| <br><b>Knowsley Council</b> | <p align="center"><b>Planning Consultation Response</b></p> <p align="center"><b>Environmental Health and<br/>Consumer Protection Service</b></p> |

| Planning App. No: | 23/02782/FUL                                                 | 24/03856/PLANNI |
| Location:         | The Sovereign Distillery, Wilson Road, Huyton, Knowsley      |                 |
| Proposal:         | contaminated land and air quality assessment                 |                 |

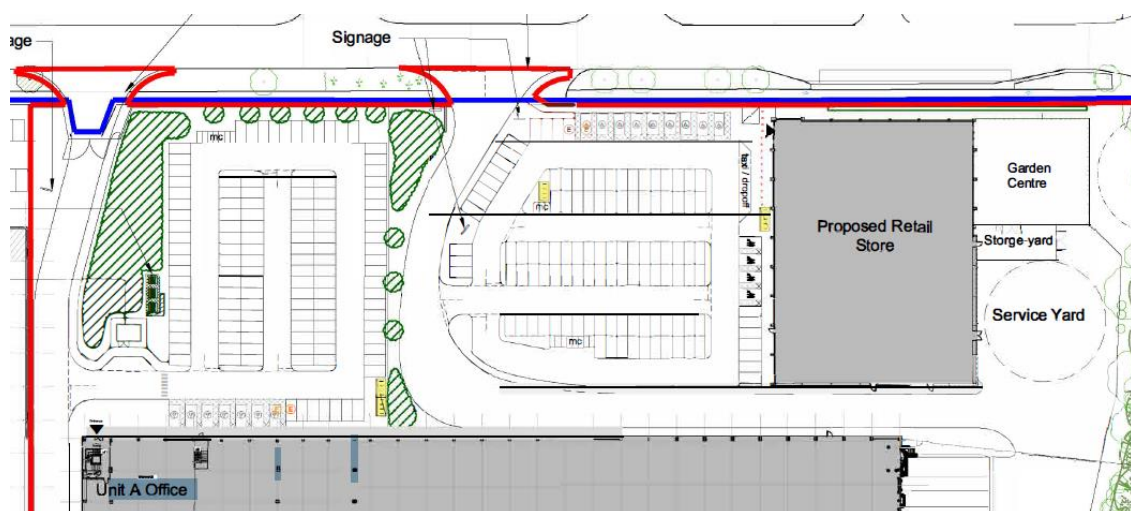
2. The Ground Investigation is cited as being primarily for geotechnical purposes. Previously identified sources of contamination do not appear to have been considered or targeted. MEAS advise that full justification should be provided for the scope of the intrusive works with reference to the potential risk to human health, including from ground gas. It should also identify any data gaps which need to be addressed.

3. The Ground Investigation report states that the proposed development will be 100% hardcover. However, the Proposed Site Plan (13579-AEW-XX-XX-DR-A-0503 Rev P12) shows significant areas of landscaping. This will need to be taken into account in terms of the scope of the intrusive works (see point 2).

The report was for both geotechnical and ground contamination. The scope of the intrusive ground investigation works was to primarily to target the proposed building / service yard with the remaining works across the site targeted to facilitate the refurbishment of the existing buildings with no significant construction works envisaged (i.e. provide information on ground conditions to existing foundations for geotechnical design purposes). Therefore, the contamination screening and ground gas monitoring carried out was targeted around the area of proposed new building with regards to risks to human health.

There is a new small area of soft landscaping proposed (see below).

The remaining green areas are existing soft landscaping / grassed areas. As noted in point 3, this wasn't noted in the intrusive report, but we consider the soft landscape area to be relatively small. Five samples were taken from this area of the development and
